PLAN COMMISSION REPORT

10Proposal: Preliminary Subdivision Plat – Parkside Subdivision

Description: Review a preliminary subdivision plat for Parkside single-family residential subdivision.

Address(es): 1340 E. Forest Hill Avenue. (3rd Aldermanic District)

**Figure 7. Preliminary
Wetland Delineation**

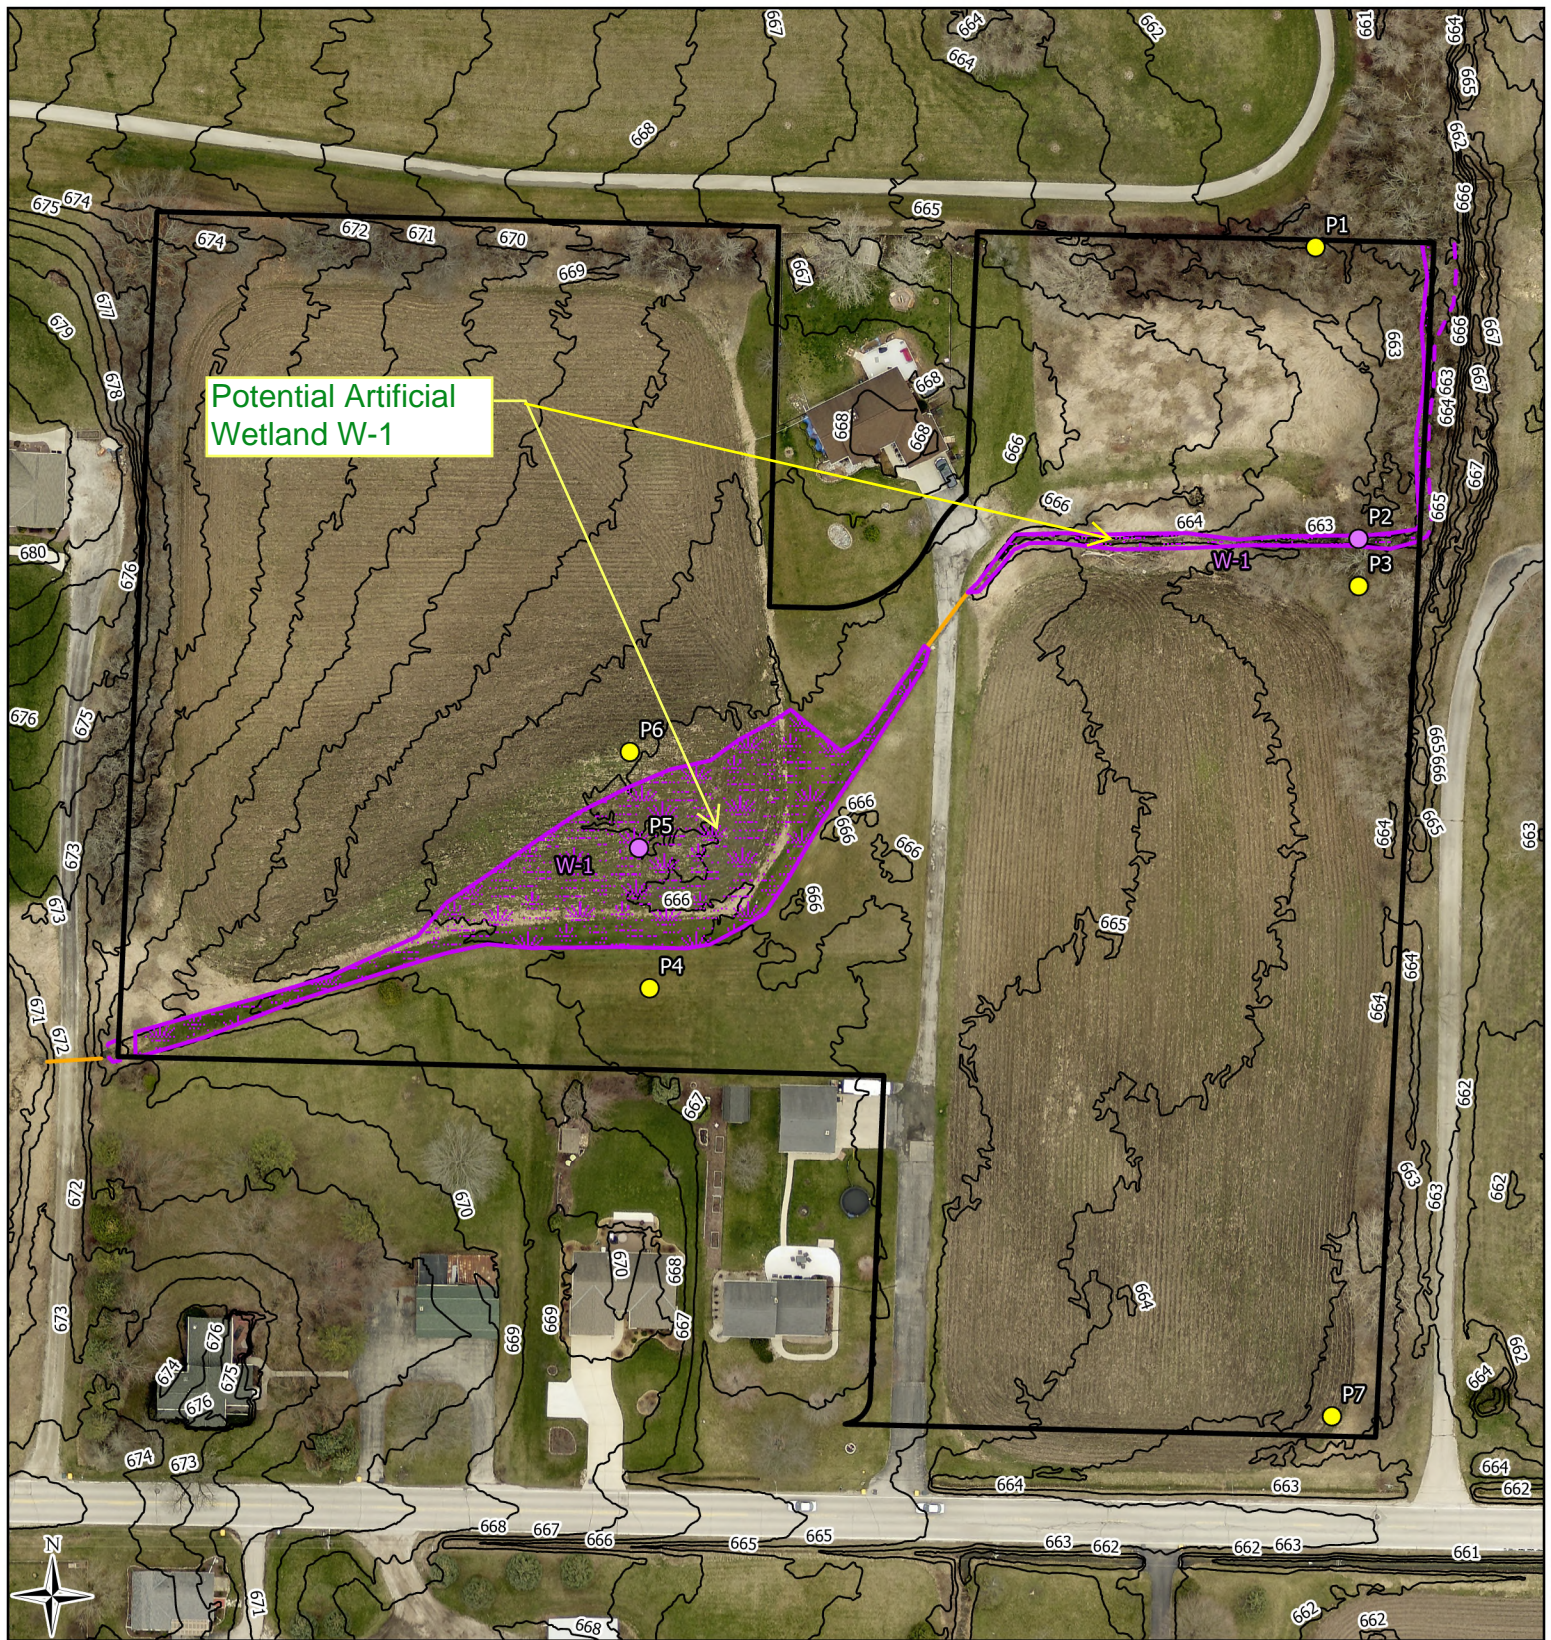
Data Point P5 obtained from the wetland delineation report within Wetland 1 shows that this feature has a depleted subsoil horizon meeting several hydric soil indicators. A depleted subsoil indicates that the soil profile in an area has experienced prolonged inundation from a high-water table. This is strong evidence that Wetland 1 developed from a natural hydrology regime and not an anthropogenic one.

Based upon the information provided above, the wetland identified as Wetland W1 had wetland history prior to August 1, 1991 and does not meet state wetland exemption standards.
